**TO:** Jessica McCallum, Kevin Roth, Kimley-Horn  
**FROM:** Amber Wood Hicken, Planner I  
**DATE:** 8/8/24  
**SUBJECT:** Parker Pointe F1 Lot 2A, McDonald's – Site Plan, SP23-070  
Review Comments 03

# PARKER POINTE SUBDIVISION FILING NO. 1, LOT 2A

**SCREEN WALL DETAIL**  
NOT TO SCALE

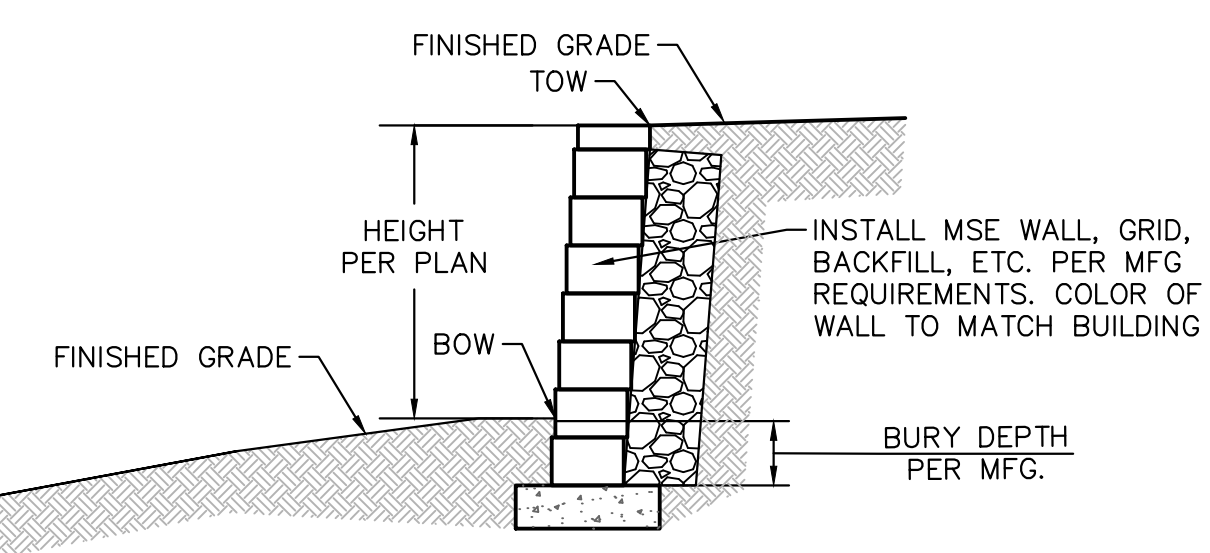
gray? please note color  
KH Response: The wall will match the gray of the building. Legend has been updated to reflect this.

please provide maximum height  
KH Response: The maximum height of the wall is 2.58', and the legend has been updated to reflect this.

## LANDSCAPE PLAN

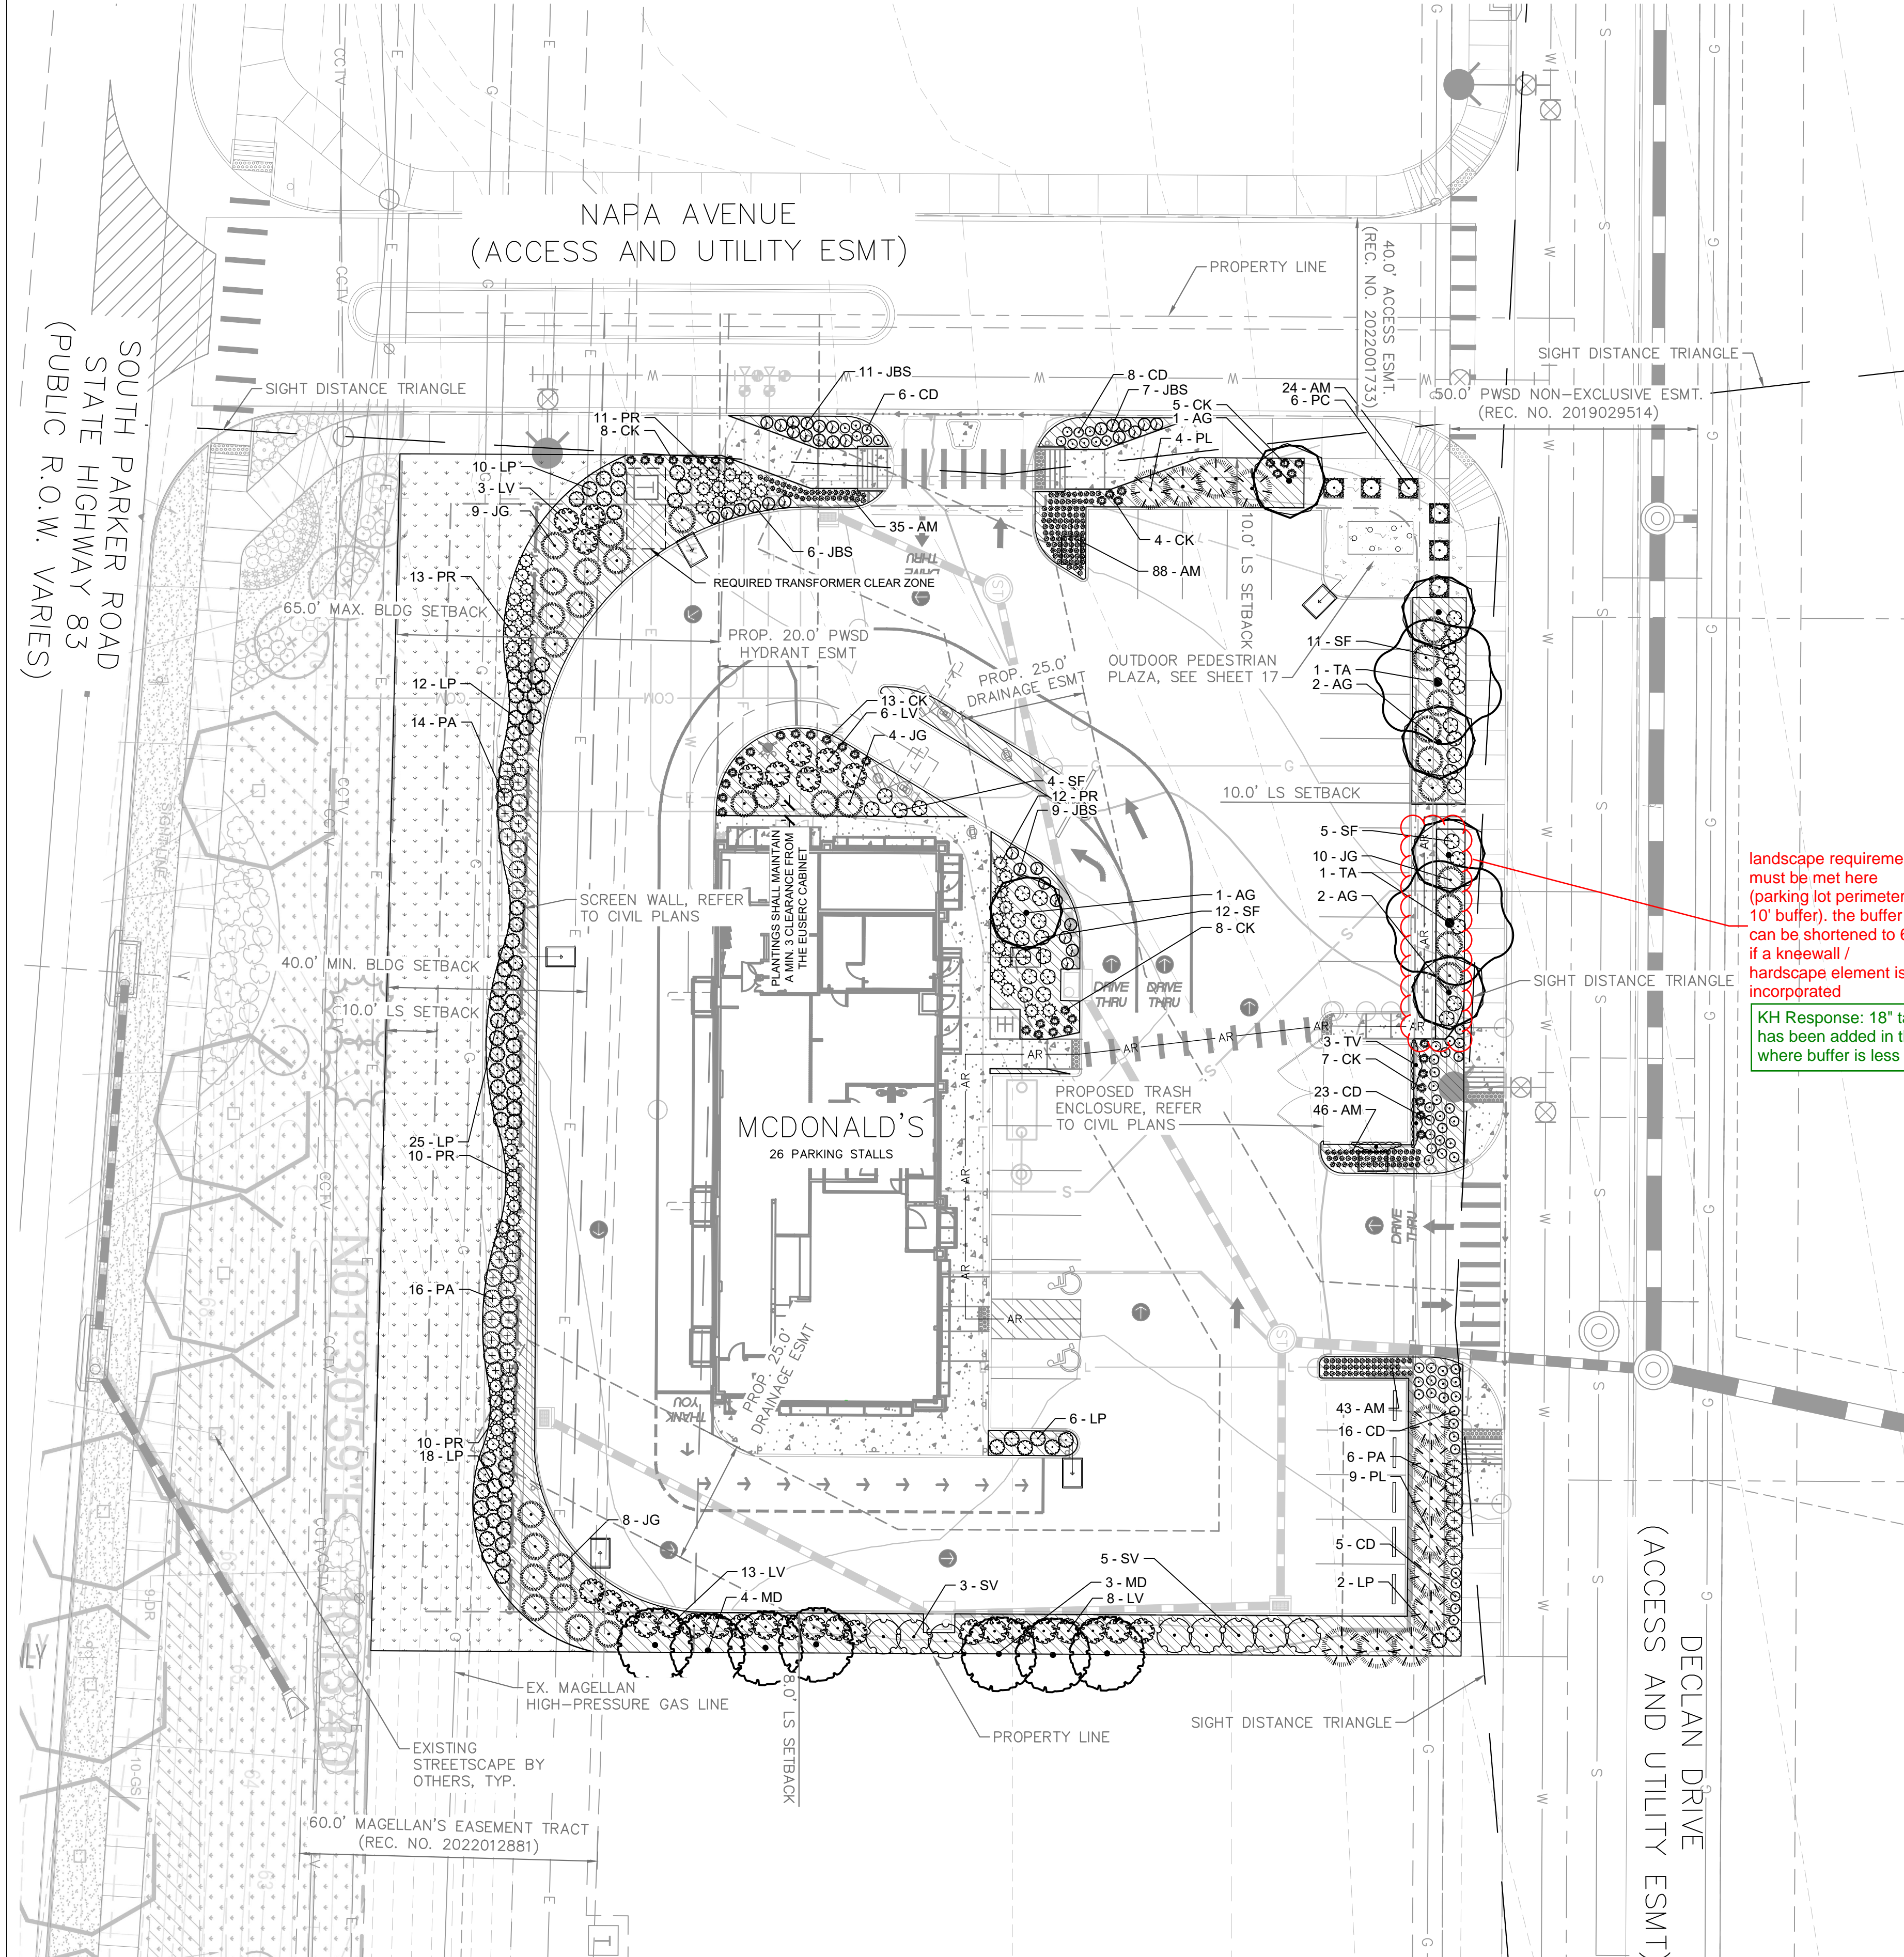
landscape requirement must be met here (parking lot perimeter - 10' buffer), the buffer can be shortened to 6' if a kneewall / hardscape element is incorporated

KH Response: 18" tall knee wall has been added in this area where buffer is less than 10' wide.
